# VALUE ENGINEERING

90% Submittal

KOSP

190010E

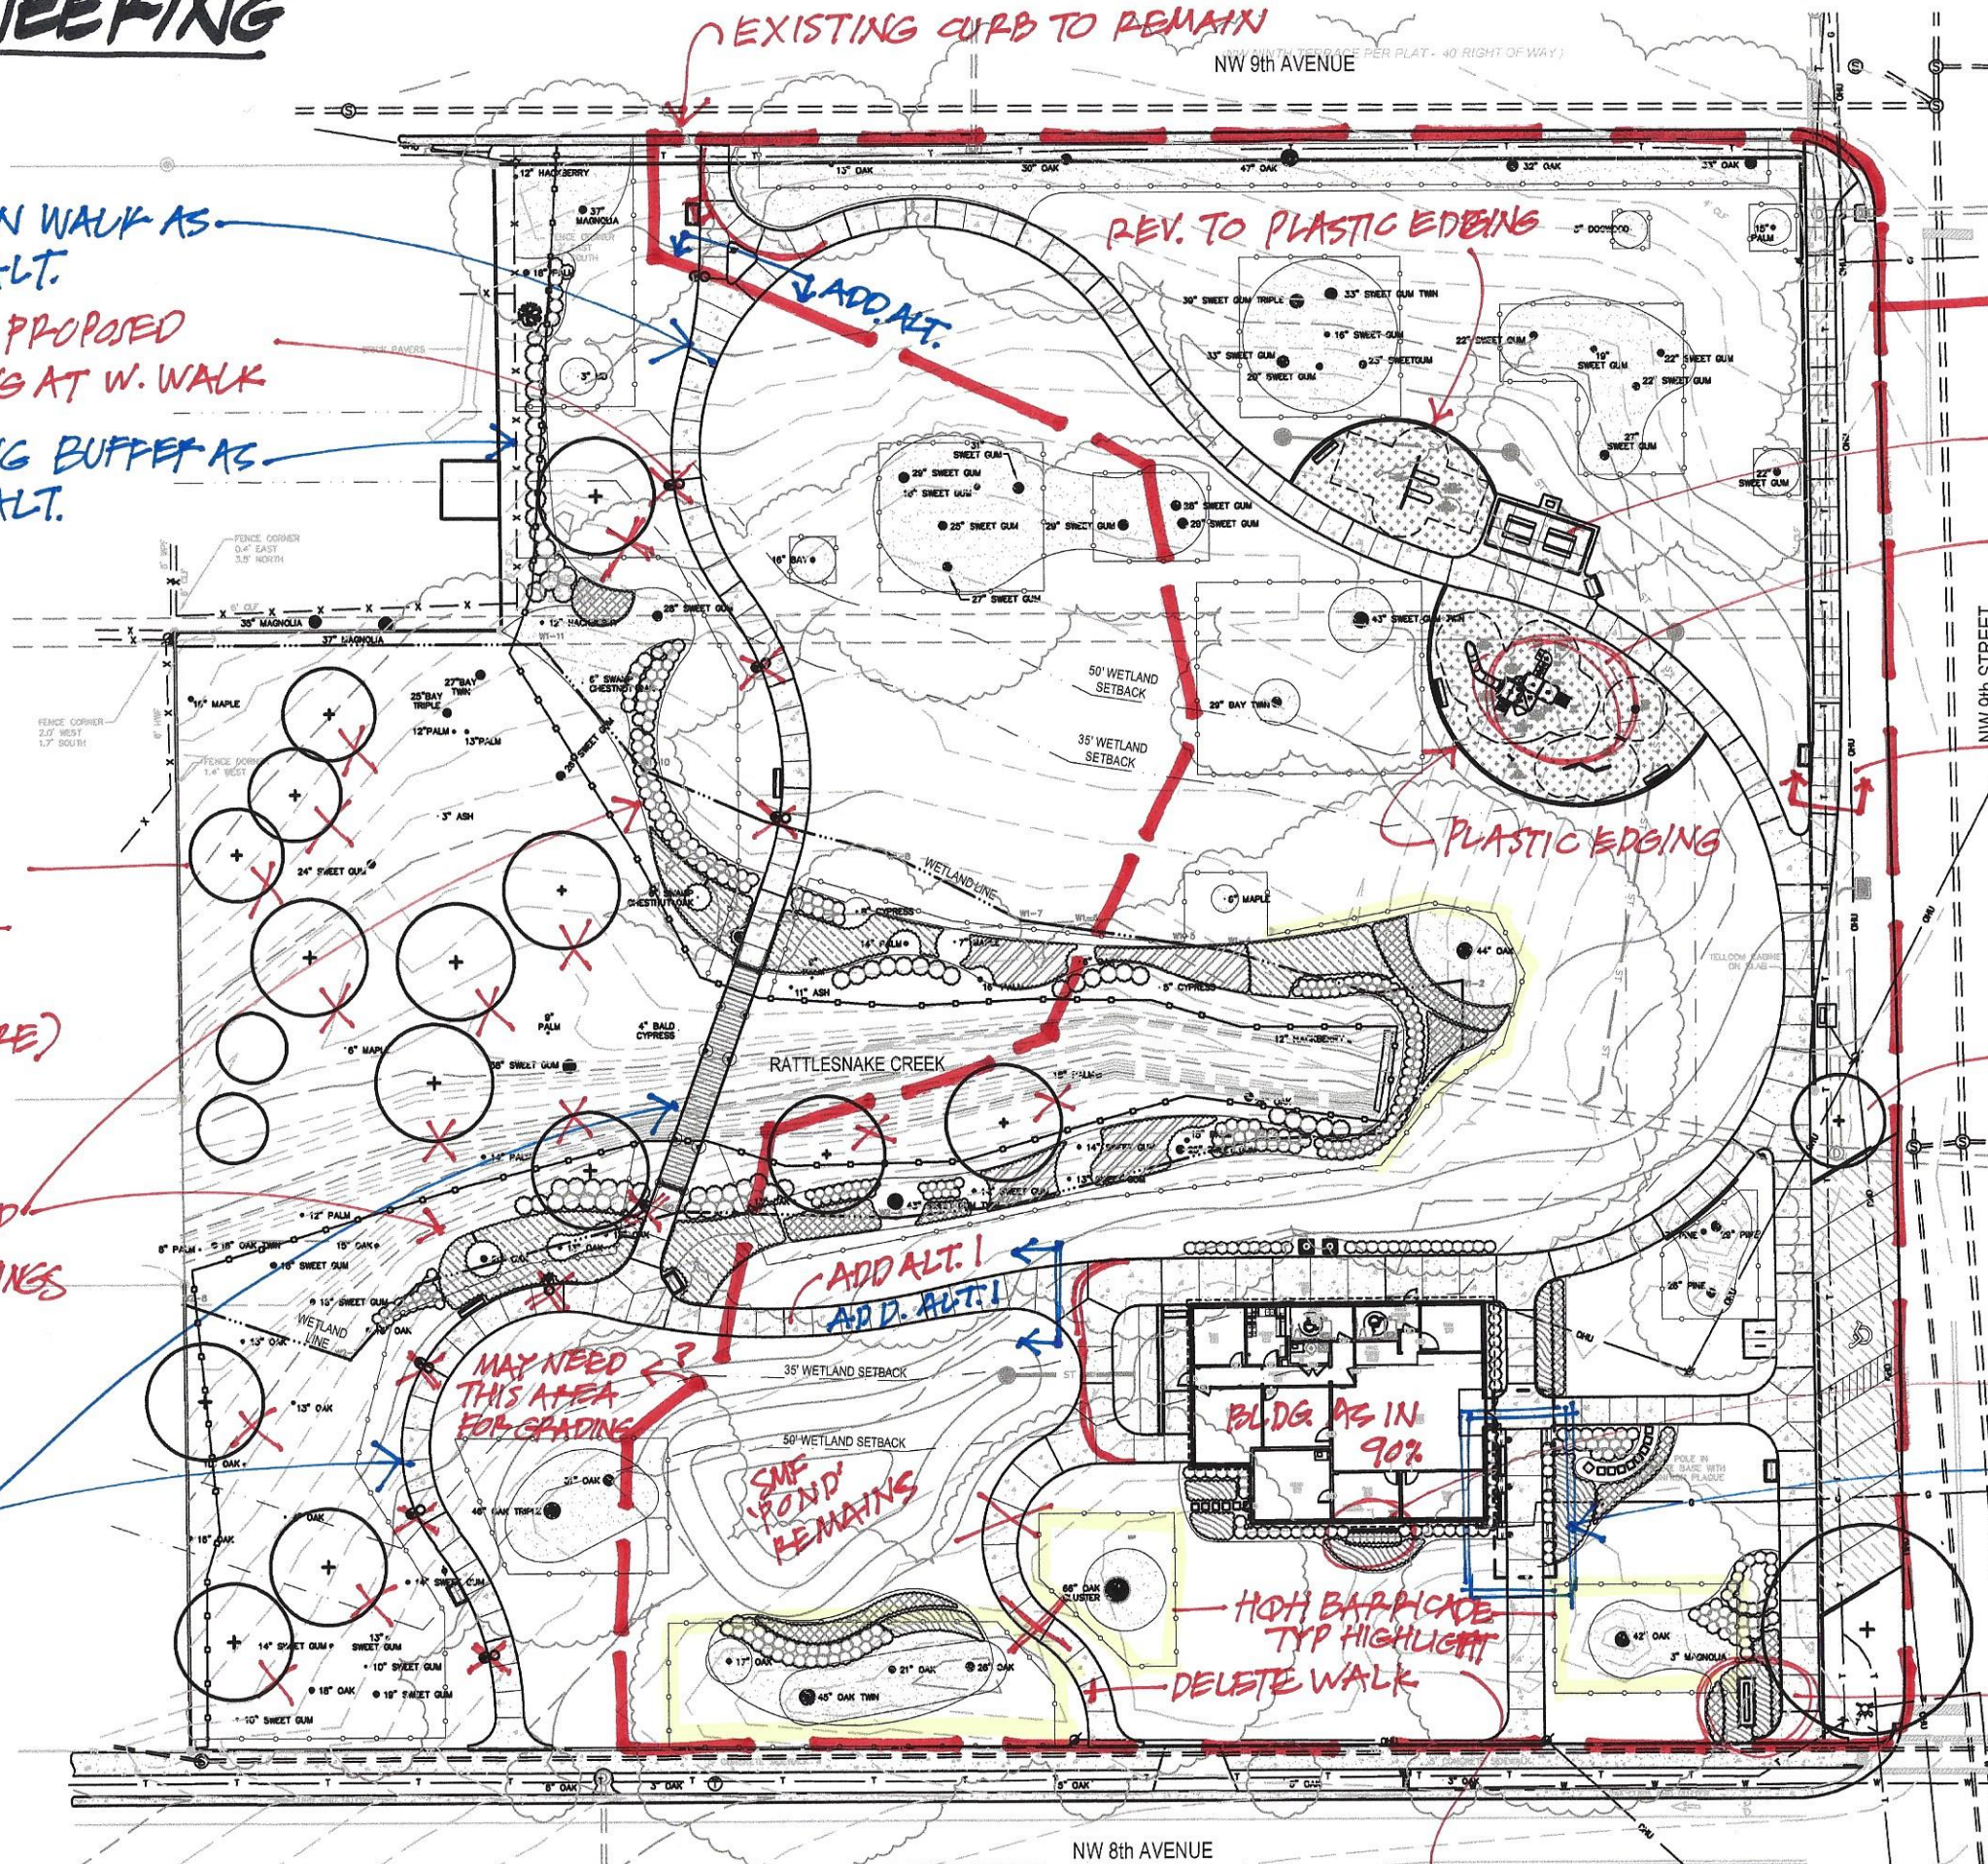
WESTERN WALK AS  
ADD. ALT.  
DELETE PROPOSED  
LIGHTING AT W. WALK  
PLANTING BUFFER AS  
ADD. ALT.

ELIMINATE ALL TREES  
NOT REQUIRED BY LDP'S -  
RECALCULATE TREE  
MITIGATION (WILL BE MORE)

INVESTIGATE IF PROPOSED  
EXOTICS AREA REPLANTINGS  
CAN BE REDUCED

WESTERN WALK AND  
BRIDGE AS ADD. ALT.

BASE BID  
LIMIT OF WORK

NO PROPOSED POWER OR  
LIGHTING @ PAVILION  
REVISIT PLAY EQUIPMENT  
SELECTION - SIMPLER/VE.

PUBLIC WORKS WILL  
REIMBURSE FOR NEW WALK  
IN RIGHT OF WAY

KEEP TREES AT PARKING

DELETE GREEN SCREEN

CANOPY AS ADD. ALTERNATE

ENTRY SIGN AS ADD. ALT.

HIGH BARRICADE CLARIFICATION - REST ARE TYP. REGULATED
